ADDENDUM NO. 3

**TO THE PLANS AND BID DOCUMENTS FOR THE UNIT 4 PHASE 2
COMPOSITE LINER CONSTRUCTION PROJECT
AT THE MID-VALLEY SANITARY LANDFILL
in Rialto, California**

January 26, 2026

MID-VALLEY SANITARY LANDFILL
 UNIT 4 PHASE 2 COMPOSITE LINER
 CONSTRUCTION PROJECT
 ENTRANCE FACILITY IMPROVEMENTS
 BYPASS LANE

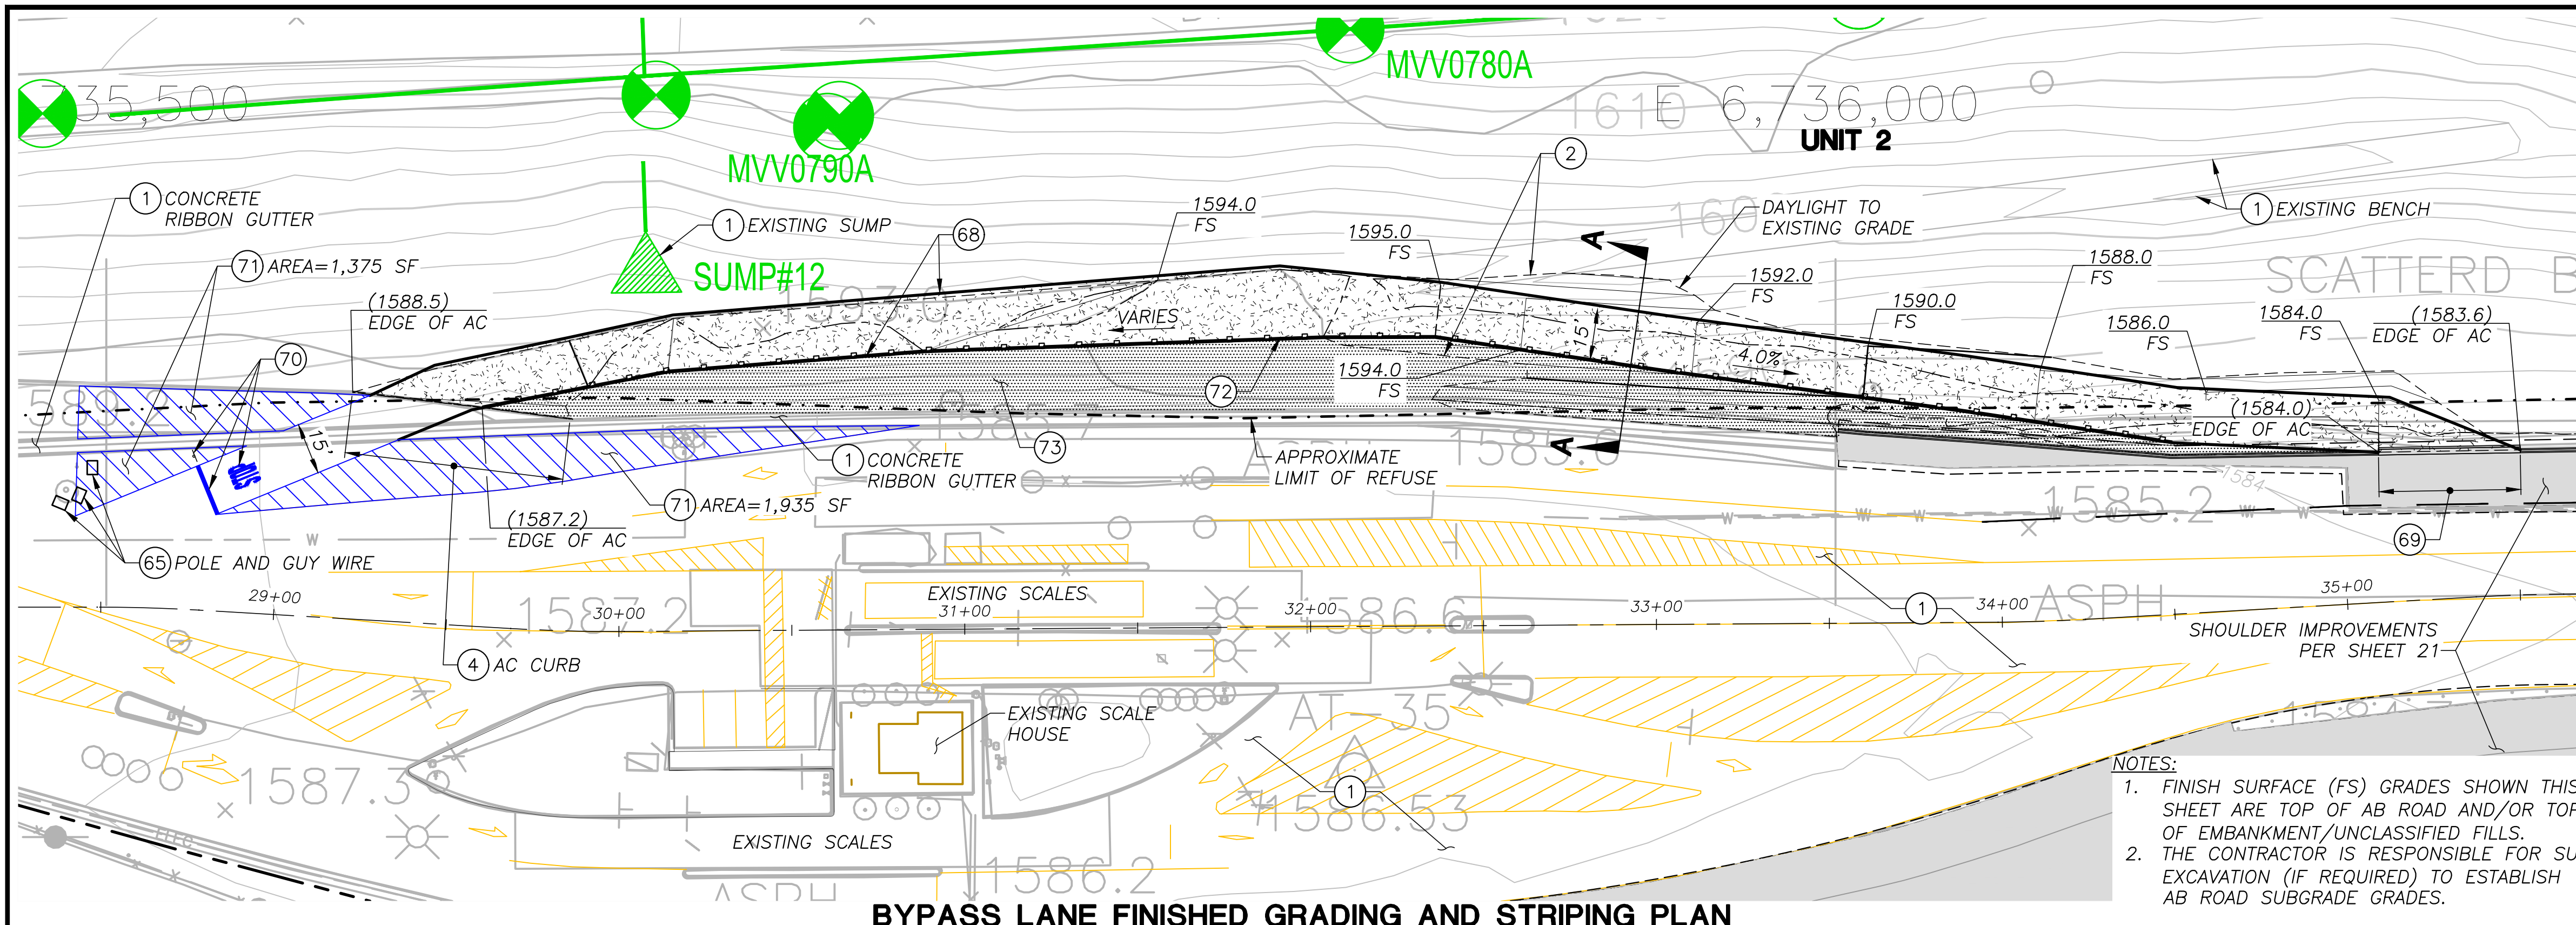
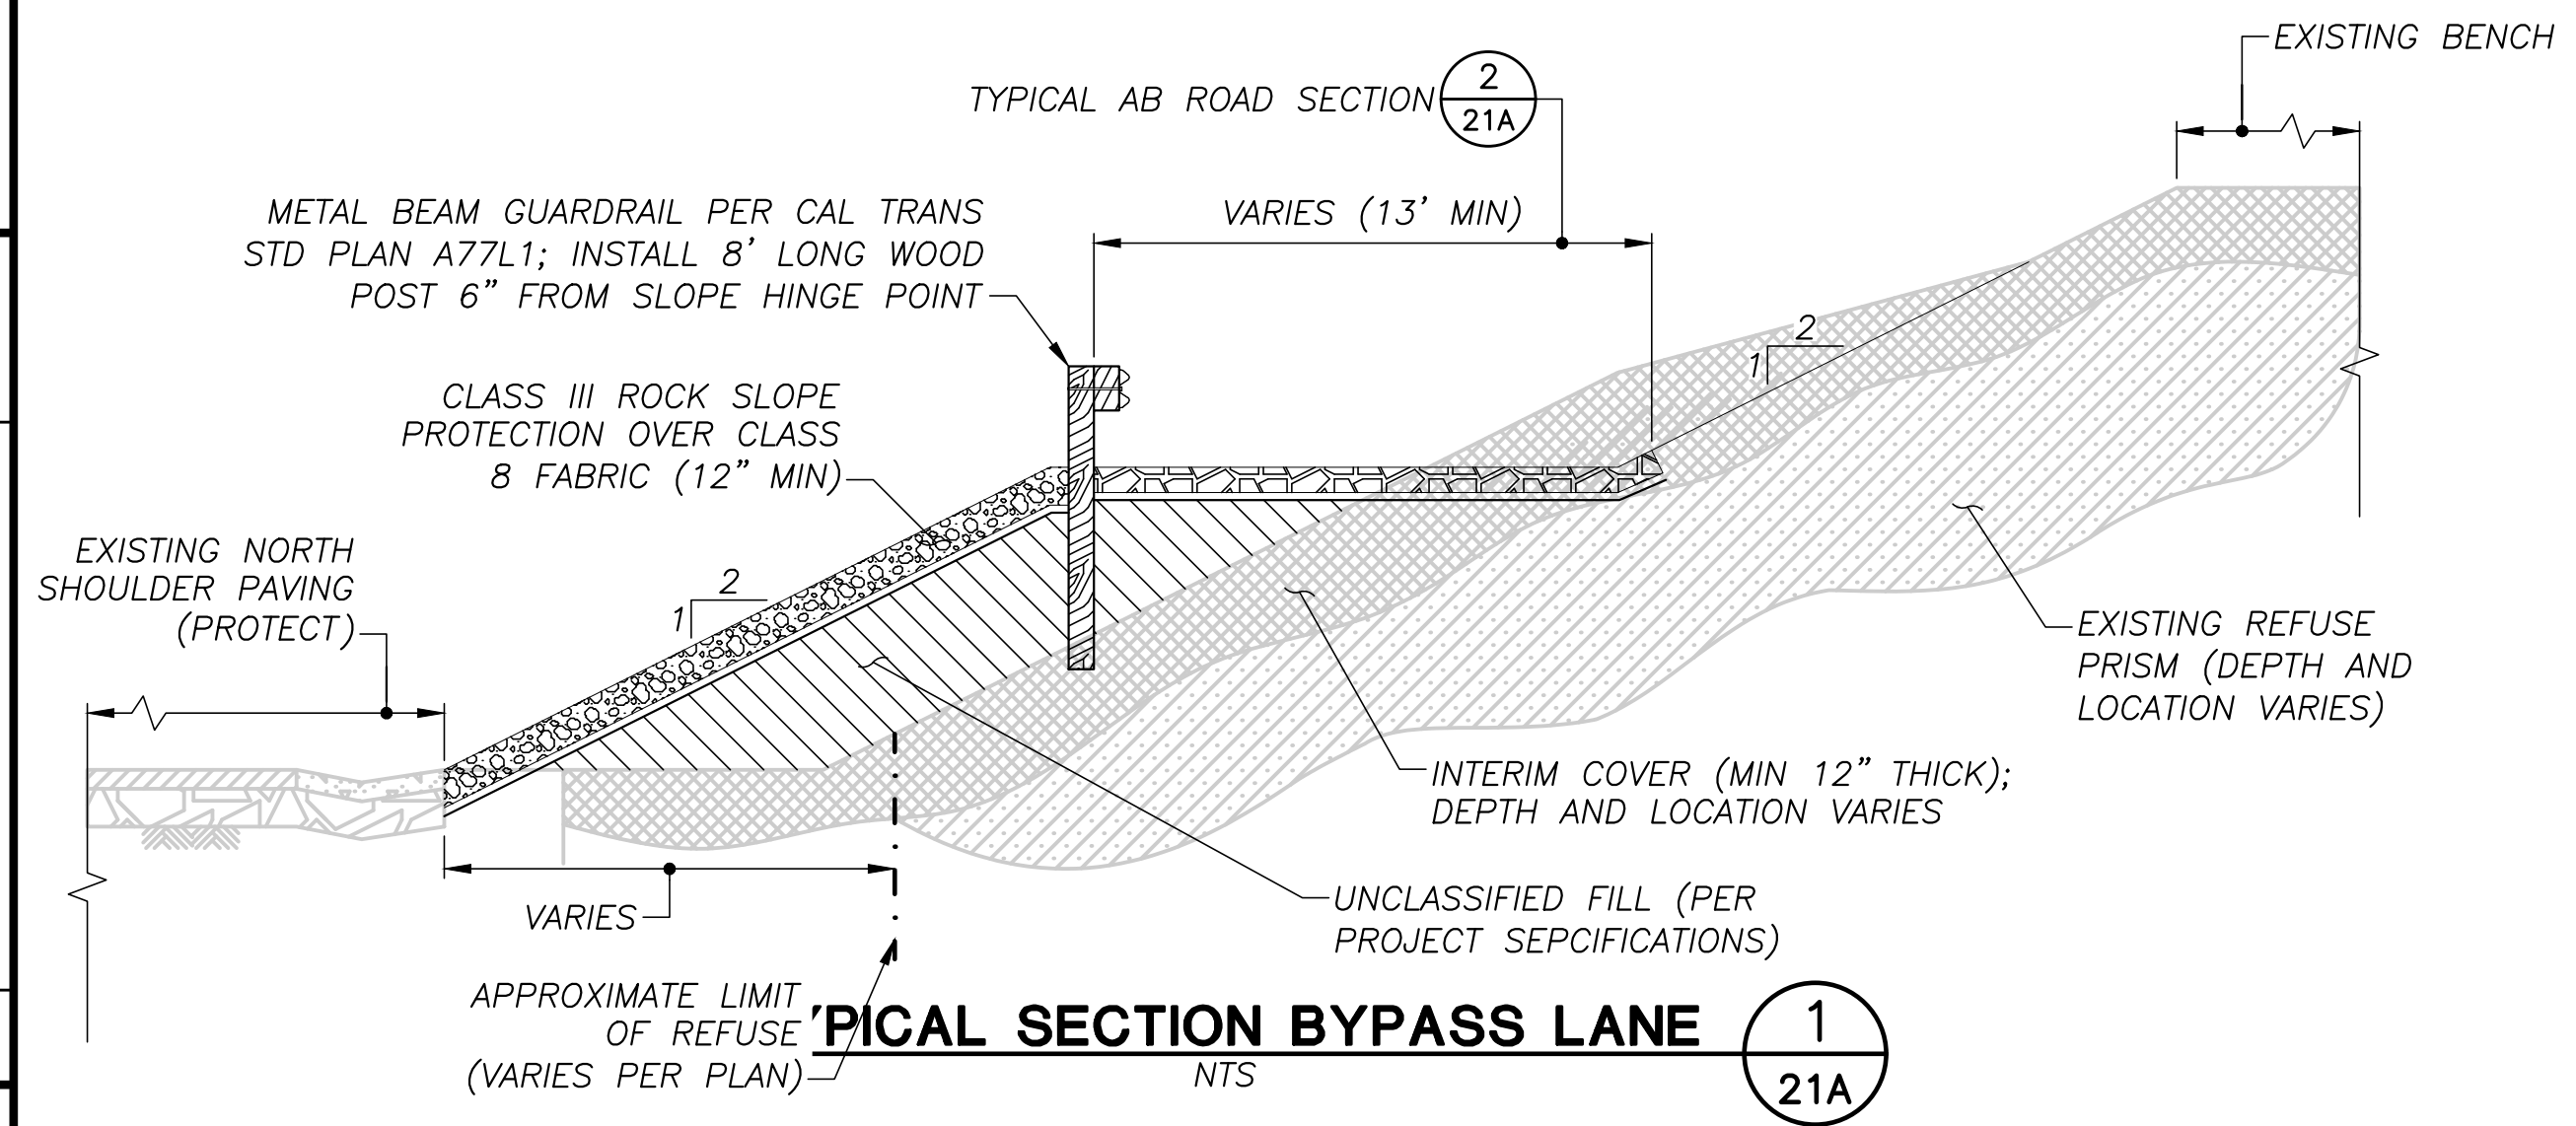
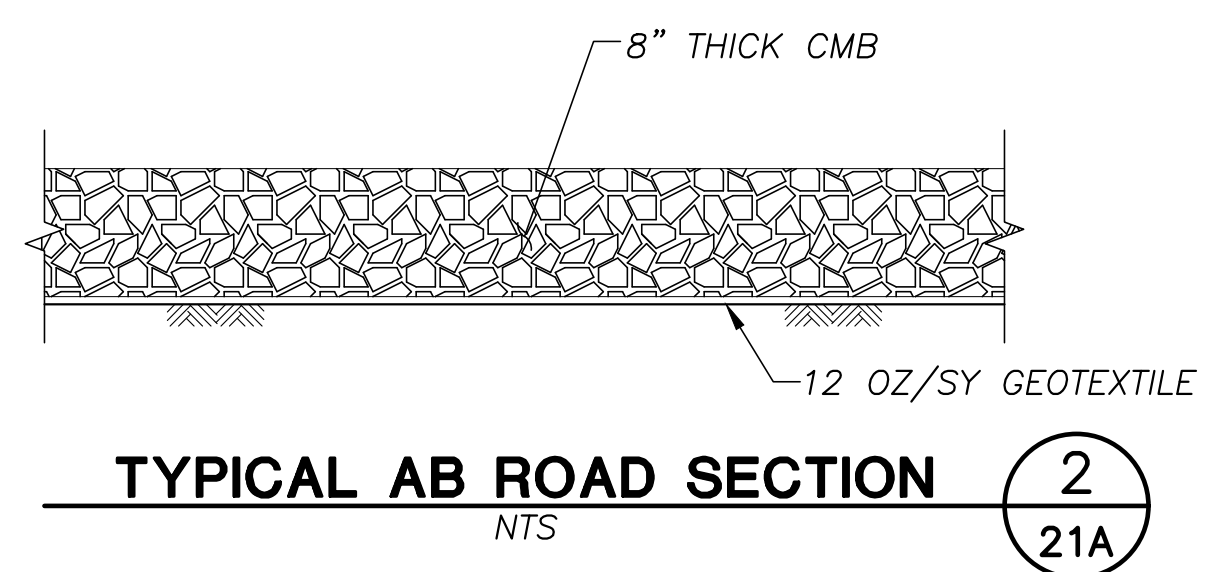
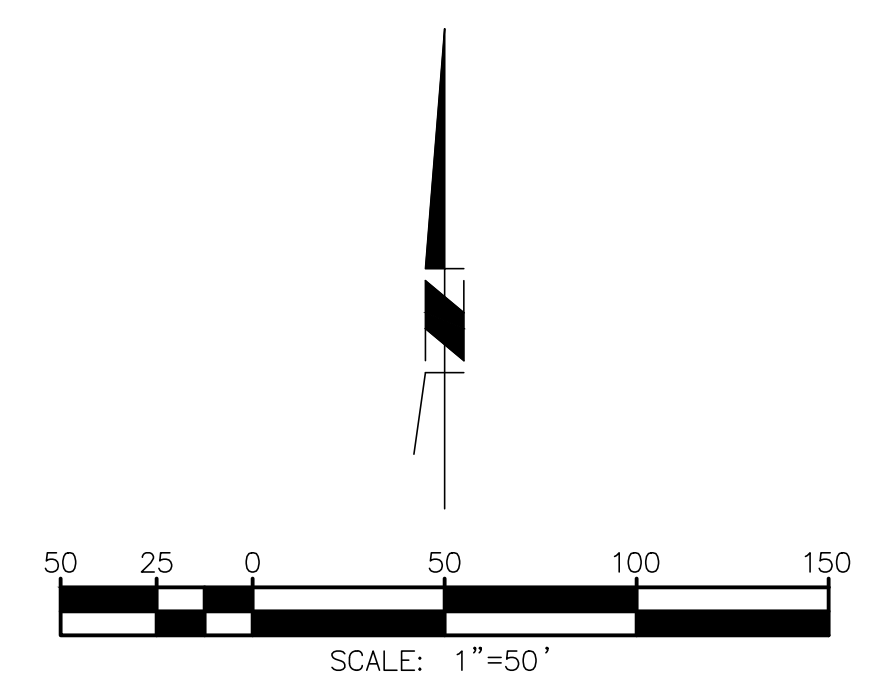
2. Add new Sheet 21A to plan set to add details related to the bypass lane improvements, included in Attachment 4 to Addendum No. 3.

- 3 EA of Concrete Block Barriers to protect existing power pole (Private) per Detail 2/22;
- Approximately 9,845 SF of Bypass Lane 8" thick CMB over 12 oz/sy Geotextile per Details 1/21A and 2/21A;

- Supply and Placement of approximately 7,865 SF of 12" Thick (Min) Class III Rock Slope Protection and RSP Fabric; Placement Method B per Detail 1/21A.

ENTRANCE FACILITY SHOULDER NORTH - SECTION

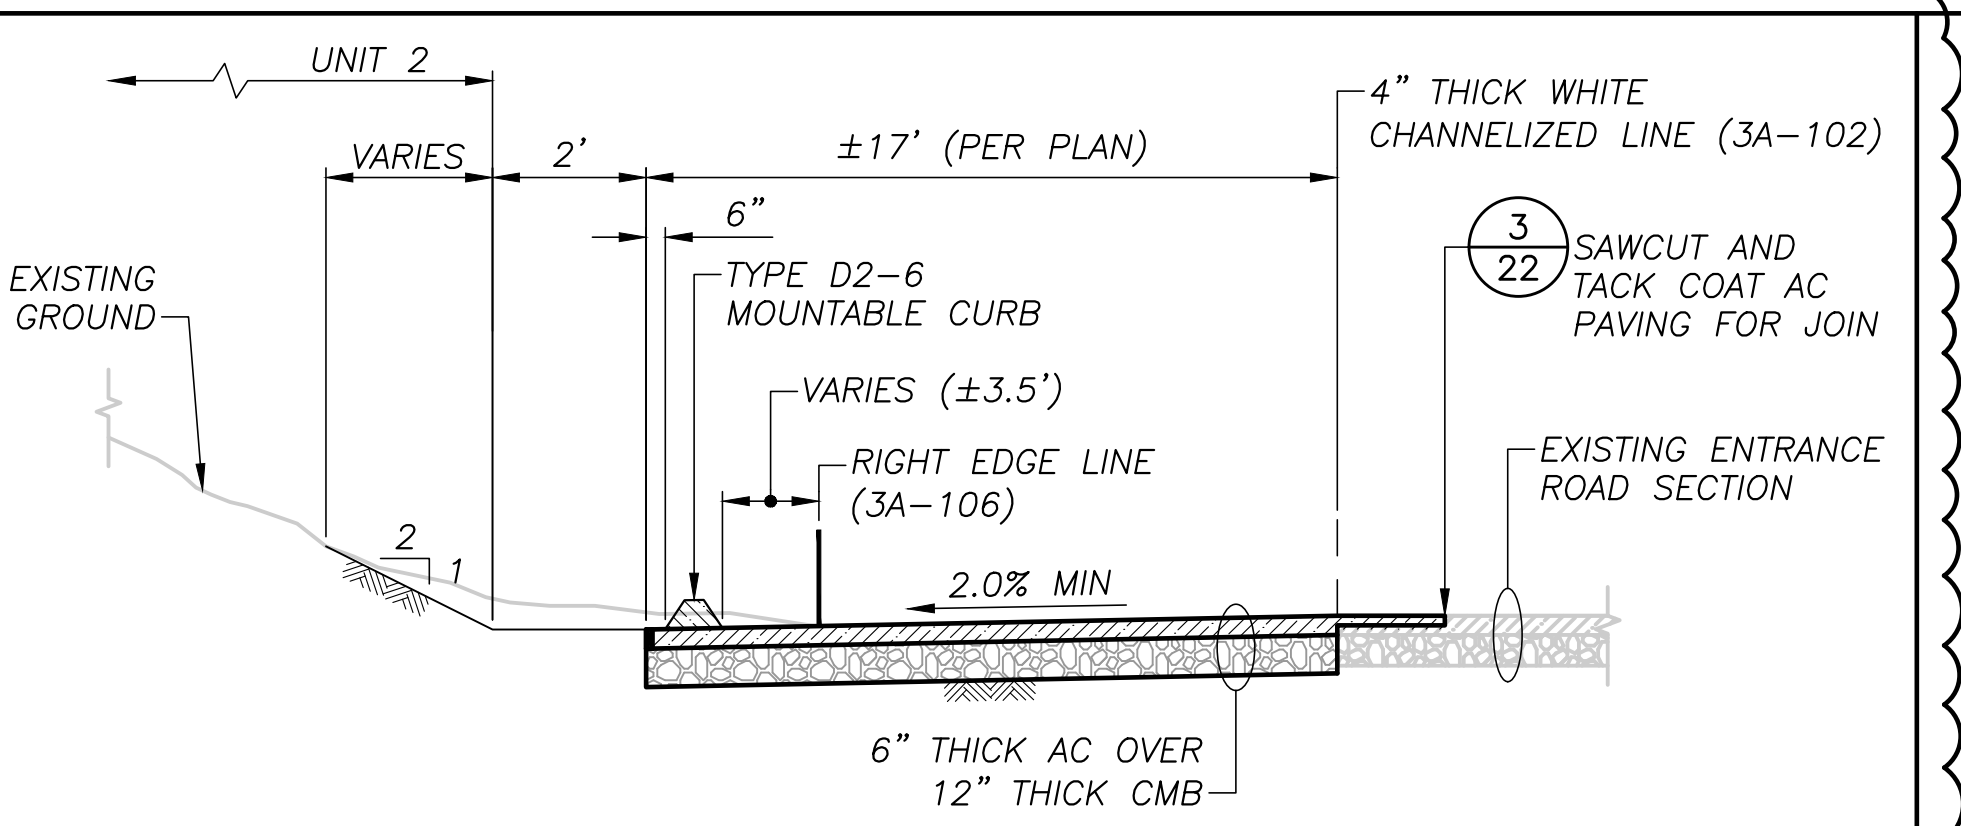
Q17. Please clarify where Item 62, “Splashwall,” is shown on the front entrance plans.

A17. Splashwalls was removed from the Entrance Facility Area Plans. The Technical Specifications were modified to replace Measurement and Payment Bid Item as specified in reissued Section 2K, Subsection 4.12, Shoulder Paving – 6-Inch Asphalt Concrete over 12-Inch CMB (Per Detail 3/28).
